PONTIAC

Service Craftsman News

NO. 11 S-300

DECEMBER 1957

Fig. 2 Wire Gauge For Directional Signal Switch

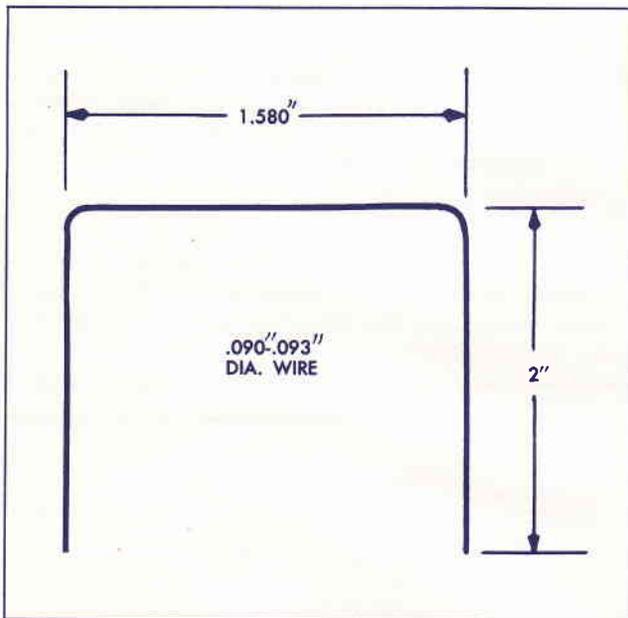
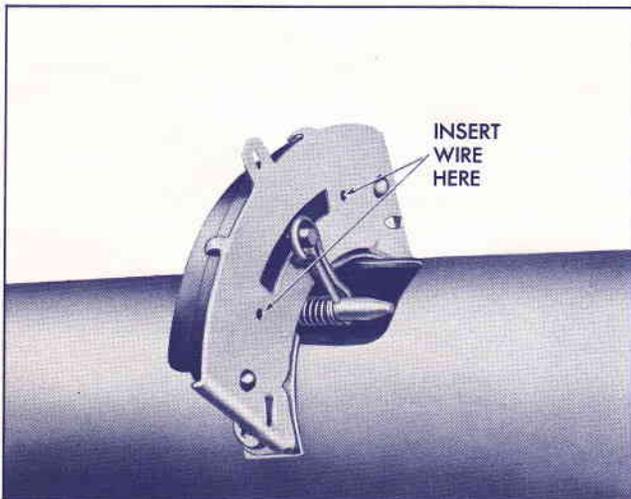
POSITIONING DIRECTIONAL SIGNAL SWITCH

Improper positioning of the directional signal switch has resulted in several cases of inoperative stop lamps. The directional signal switch is mounted in a slotted bracket and must be carefully centered on the steering column to ensure proper stop lamp and signal operation.

To positively position the switch a piece of .090" wire bent as shown in Fig. 2 can be used. The ends of the wire should be inserted in the two holes on the face of the switch (Fig. 3) before the attaching screws are tightened. If the switch is positioned so that the wire enters both holes freely, when in neutral position, it is centered correctly on the steering column.

Fig. 4 Correct Position Of Accelerator Linkage

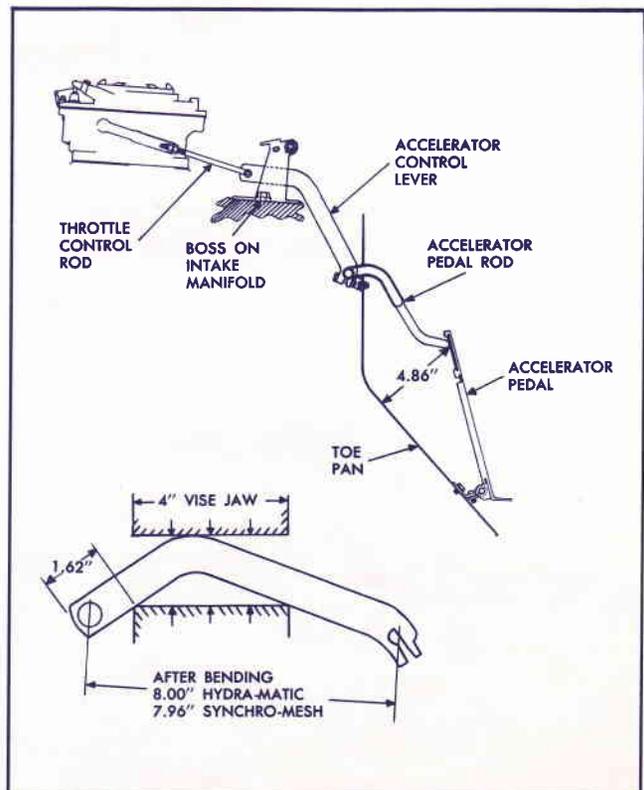
Check Clearance Of Accelerator Control Lever On 1958 Models

The specified accelerator pedal height from top of spherical end of pedal rod to body toe pan (underneath carpet) is 4.86" as shown in Fig. 4. On some early 1958 cars this dimension allows the accelerator control lever to come too close to the intake manifold. If the control lever is adjusted to provide adequate clearance at the manifold, the accelerator pedal will be lowered resulting in loss of pedal travel and making the 4-3 transmission downshift difficult to obtain.

When difficult 4-3 downshift on early 1958 cars is reported, check clearance of accelerator control lever and correct, if necessary, as follows:

1. Make sure accelerator pedal is adjusted to proper 4.86" height.
2. If this proper pedal height brings control lever less than 1/2" from intake manifold, remove control lever from car and rework in vice jaws as indicated in Fig. 4.
3. Reinstall control lever.

Fig. 8 Drill Holes In Primary Throttle Plates

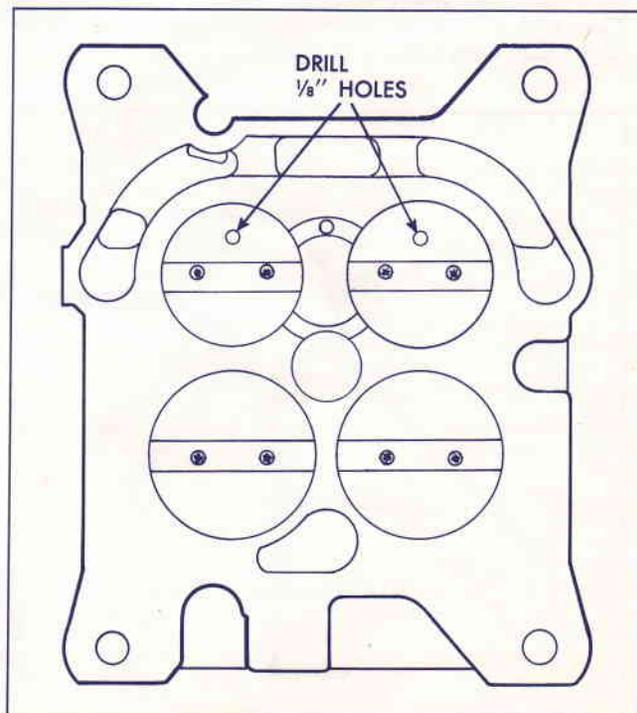
Correction For Carburetor Stalling Due To Gum

A corrective procedure has been developed which will eliminate rough idle and stalling complaints caused by build-up of gum in the carburetor throttle bores. The correction, outlined below, consists of drilling a 1/8" hole in each primary throttle valve and performing the necessary idle adjustments. Care should be used when drilling to ensure no distortion of the throttle shaft. Center punching of valves before drilling should not be necessary.

1. Remove carburetor. Do not remove gum deposits from throttle bores.
2. Invert carburetor and drill a 1/8" diameter hole in each primary throttle plate as shown in Fig. 8. Do not drill secondary throttle plates.
3. Blow out any loose chips and re-install carburetor using new carburetor to manifold gasket.
4. Reconnect throttle linkage and adjust hot idle speed to 500 rpm in drive range.
5. Adjust carburetor throttle rod setting with gauge pin. It will usually be necessary to shorten throttle rod slightly to get correct adjustment.
6. Adjust mixture screws to give best quality idle.

Fig. 9 New Carter Carburetor

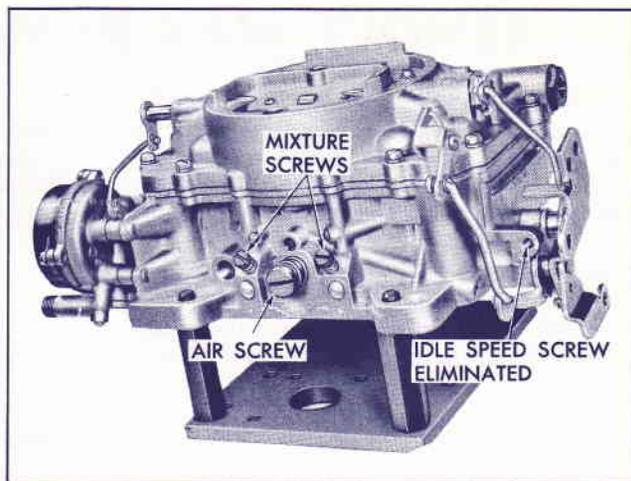
New Carter Carburetor Released For Production

A new Carter 4-Barrel Carburetor incorporating an air by-pass type idle system is now being used in production.

Service Procedures and adjustment specifications remain the same on the new carburetor with the exception of those involving the idle circuit and fast idle setting.

In the new system idle air no longer flows past the throttle valves but is directed through a separate passage around the throttle valves and metered by the position of the by-pass air screw (See Fig. 9). The throttle valves are completely closed on hot idle.

The conventional idle speed screw has been eliminated and hot idle speed is controlled by the air screw. Under no circumstances should an idle speed screw be installed on this carburetor.

1. As a preliminary setting turn air screw out 2-1/2 turns from lightly seated position and mixture screws out 1 turn.
2. Set hand brake securely, place transmission in neutral and connect tachometer to engine.
3. Start engine and warm up thoroughly. Make sure choke is fully open and carburetor is completely off fast idle.
4. Put transmission in "drive" and adjust the air screw to obtain a reading of 480-500 rpm.
5. Turn mixture screws to best quality (highest rpm) idle.
6. Reset air screw to 480-500 rpm if mixture adjustment changed setting.
7. Re-check mixture adjustment to insure smoothest possible idle.

Fig. 10 Snap Ring Against Part Retained

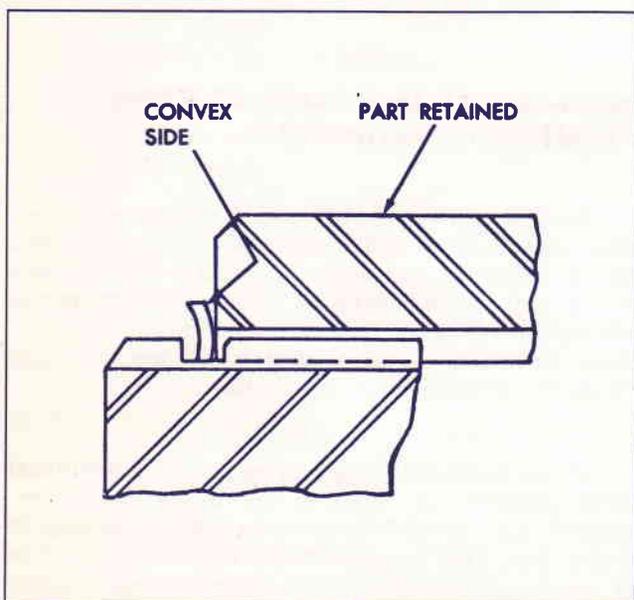
INSTALL H.M. SNAP RINGS WITH CONVEX SIDE AGAINST PART RETAINED

The September-October issue of the Service Craftsman News had an article entitled "Replace Snap Ring When Removing Drive Torus". This article is on page 70 of that issue.

An additional piece of important information concerning the above subject was recently brought to our attention which is: snap rings used in Hydra-Matic transmissions have slight convex and concave sides and should be installed with the CONVEX side against the part being retained (See Fig. 10).

Fig. 11 Rear Splash Apron Location

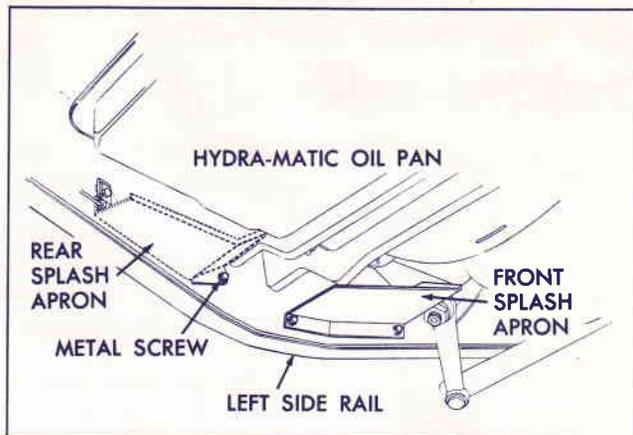
Location of Hold-down Straps Changed On Rail Shipped Cars

The location of the hold-down strap for 1958 Hydra-Matic equipped cars shipped by rail has been changed from that indicated in the November issue of the Service Craftsman News (Page 78). It has been removed from the front splash apron area to the area of the rear splash apron. Therefore, the front apron attaching screw is no longer removed.

Production is now removing the rear splash apron in order to attach hold-down straps. This apron and the attaching screw are placed in the glove box.

The splash apron must be re-installed on the left frame side rail below the Hydra-Matic transmission linkage before delivery of a car. The slotted end of the apron fits under the parking brake cable retaining screw (See Fig. 11). The front end of the apron is held to the frame by a metal screw.

Fig. 12 Clip to Position Parking Brake Cable

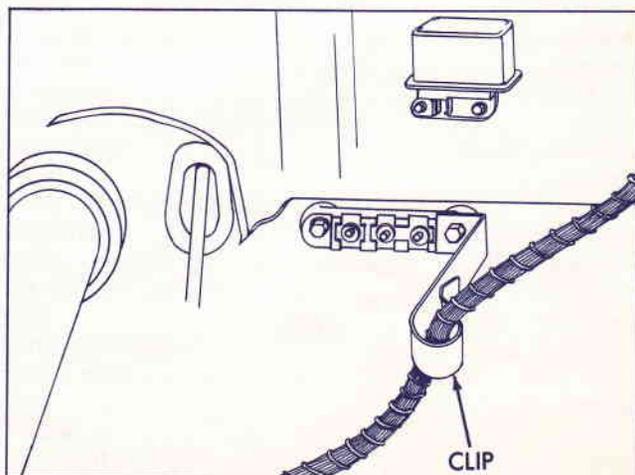
INSTALL CLIP TO POSITION PARKING BRAKE CABLE

On all 1958 Pontiac models built prior to November 5, 1957, there is a possibility of contact between the parking brake cable and the solenoid junction block terminals. This is the junction block mounted on the firewall level with and to the left of the steering column. Contact is most likely to occur as the brake is applied suddenly as this produces a "whipping" action of the cable.

Contact of cable with block will result in burning of the cable conduit and failure of the parking brake. To avoid any possibility of this occurrence a clip (part #530235), must be installed on all cars built prior to November 5. This clip is mounted on the outboard junction block screw as shown in Fig. 12. Replace present retaining screw with longer screw (part #3651216) or comparable screw. The end of the clip must be bent securely around the cable; however, no retaining screw is necessary.

Fig 13 Choke Heat Tube In Intake Manifold

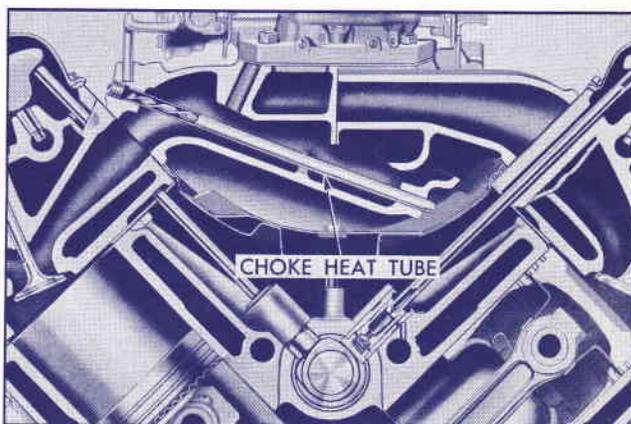
BROKEN CHOKE HEAT TUBE MAY BE REPLACED

If the choke heat tube in the intake manifold (See Fig. 13) is damaged and requires replacement, it is not necessary to replace the entire manifold.

The choke heat tube and its baffle are serviced separately (part numbers 518256 and 518220 respectively) and can be replaced in the following manner: (1) remove intake manifold, (2) remove 1/8" pipe plug and (3) using a square faced punch drive the tube from each end into exhaust chamber of manifold and remove.

To install new tube (1) press tube into manifold until tube clears vertical passage (to choke pipe), (2) install baffle, (3) install 1/8" pipe plug and (4) re-install manifold.
